MATRIX	Service Bulletin	
	Control Zone	
Effective Date: July. 15, 2014	Models Affected:	Bulletin Number
Prepared by: Eric Chen	C-5x/7x-01-F (CS17), C-5x/7x-02-F (CS22) C-5x/7x-03-F (CS23)	NB-1407006

Table 1: The ClimbMill frames and 3 IR control zone combinations

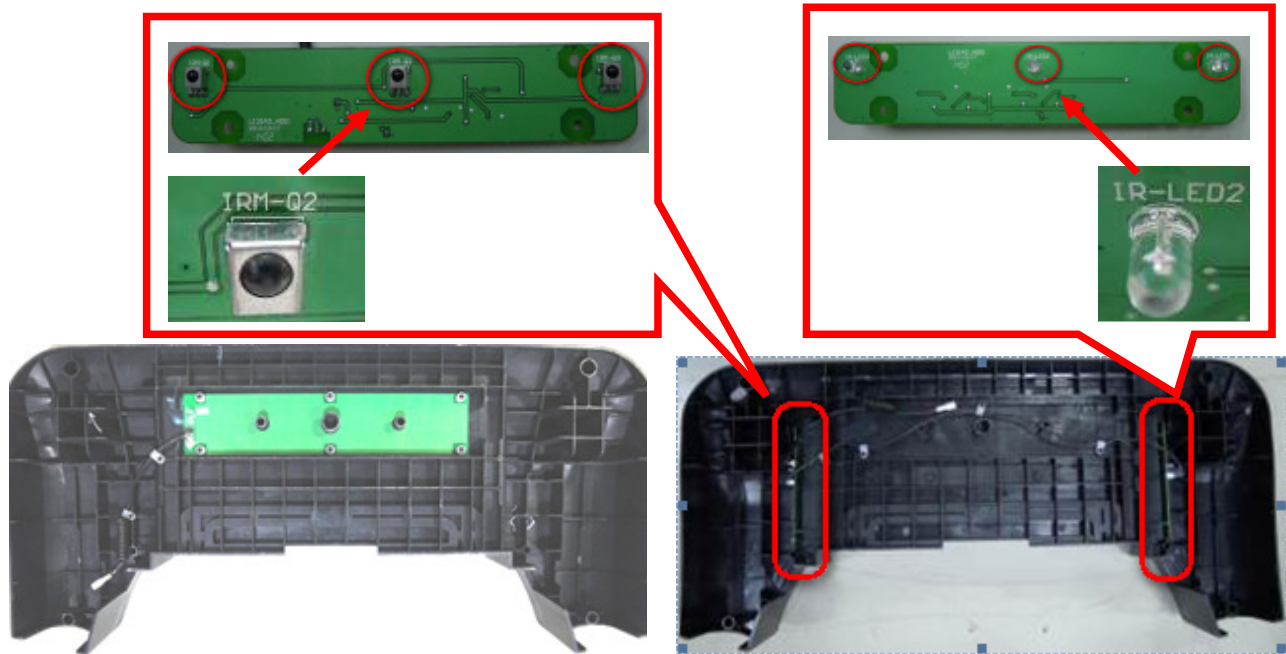
1. Table 1 shows the frame and 3 IR control zone combinations. There are three combinations.
2. For current C-5x/7x-01/02-F (CS17/CS22) in the field, if it has to be changed to the new 3 IR control zone, please also replace the LCB. Replacement LCBs have updated software (S006 or above) that supports the new control zone.
3. For current C-5x/7x-03-F (CS23) in field, if it has to be changed to the new 3 IR control zone, please purchase and install the transfer board (part number **1000336920**) into the LCB.
4. The consoles are compatible with the old and new E-stop control zone.
5. The new application is available from August 2014.

Combination	1	2	3
Frame model s/n	C-5x/7x-01-F(CS17)	C-5x/7x-02-F(CS22)	C-5x/7x-03-F(CS23)
E-stop control zone	new (3 IR)	new (3 IR)	new (3 IR)
Upgrade the LCB software to S006	Y	Y	Y
Replace the LCB (If the software can't be upgraded)	Y (LCB: 1000203336)	Y (LCB: 1000203336)	Y (LCB: 1000336916)

The new 3 IR control zone is part number **1000336928**.
